Site: Del Webb at Mirehaven Ph 3 and 4

Re: Drainage Ordinance (14-5-2-1) Violations for Erosion and Sediment Control and Construction Site Waste(s)

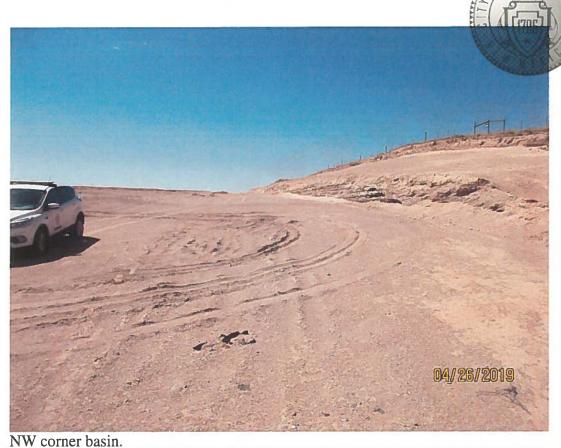
Sediment entering storm drain system. Pond to be re-established.

- 3. Remove sediment from storm drain openings and provide a sediment BMP at the storm drain. The pond in this area is to be reestablished.
- 4. Remove sediment from the street(s) and gutters.

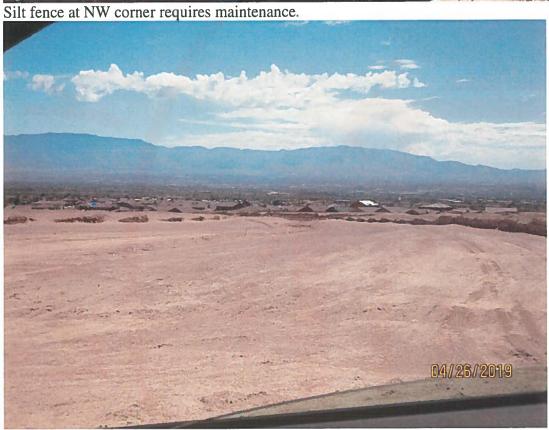
NW corner. A temporary sediment pond is to be built here.

- 2. Some of the streets are relatively steep (e.g. Sugar Creek Lane 3.43%, Wood Creek Lane 4.85%). Stormwater will achieve an erosive velocity at these grades. Provide BMPs to minimize velocity and provide temporary sediment ponds. Per the CGP the ponding area is 3600 cu. ft per acre drained.

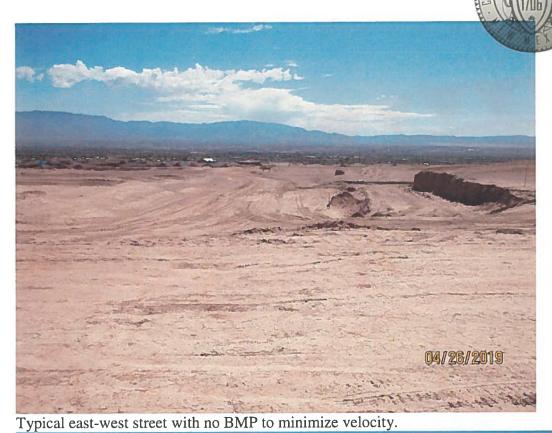
Typical east-west street with no BMP to minimize velocity.
